Subject: SQUEAK NOISE FROM FRONT BRAKES AND/OR GROOVE MARKS ON FRONT DISC PLATE	Bulletin No.: 04-002/17
	Last Issued: 08/11/2017

2014-2016 Mazda3 (Japan built) with VINs lower than JM1BM*****355941 (produced before June 23, 2016)

2017 Mazda3 (Japan built) with VINs lower than JM1BN*****144508 (produced before March 8, 2017)

2016-2017 CX-3 with VINs lower than JM1DK*****171927 (produced before March 8, 2017)

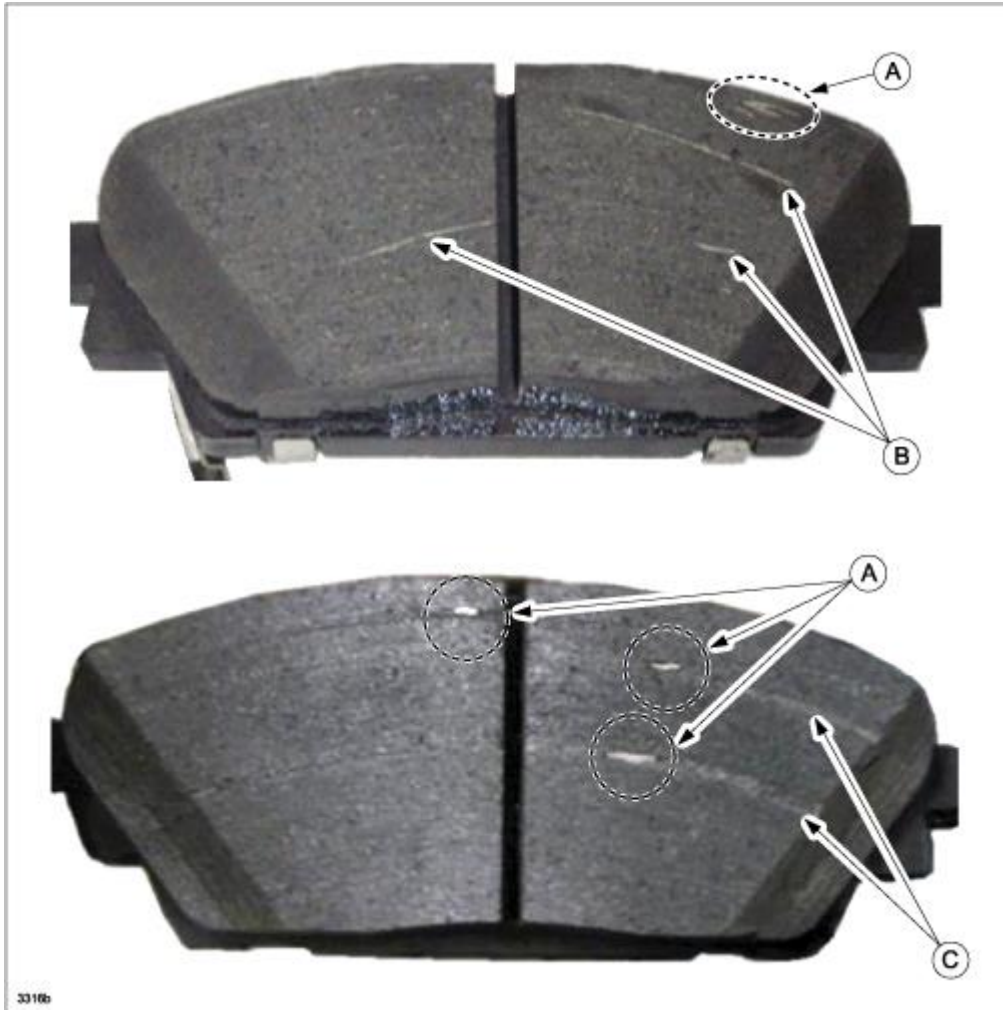
Some vehicles may exhibit a squeak noise when applying the brakes and/or groove marks (A) on the front disc plates. This is caused by abrasive metal from the front disc plate sticking to the brake pad, which damages the disc plate over time. To correct the problem, a modified brake pad is being used.

Customers having this concern should have their vehicle repaired using the following repair procedure.

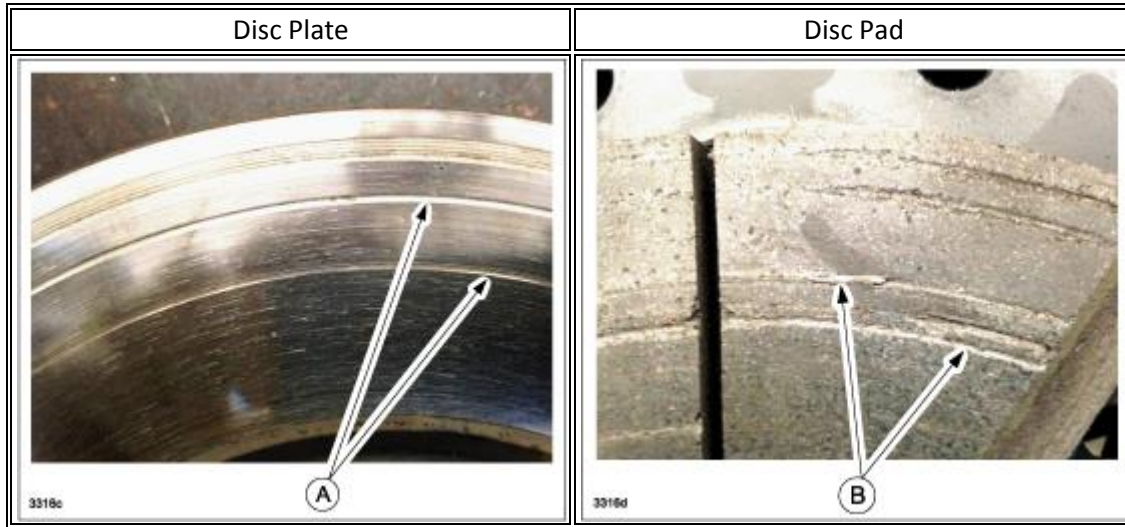
- If metal pieces (silver or white in color) are found in a cluster (A) or line form (B) on the surface or there is groove damage (C), replace the front brake pads with a modified service set.

- If groove damage is found on a disc plate (A) and brake pad (B), replace the front brake pads with a modified service set and **ONLY** the damaged disc plate(s).

NOTE: Metal may have dropped off the brake pad, and groove damage will be found on the brake pad in the same position as damage on the disc plate.
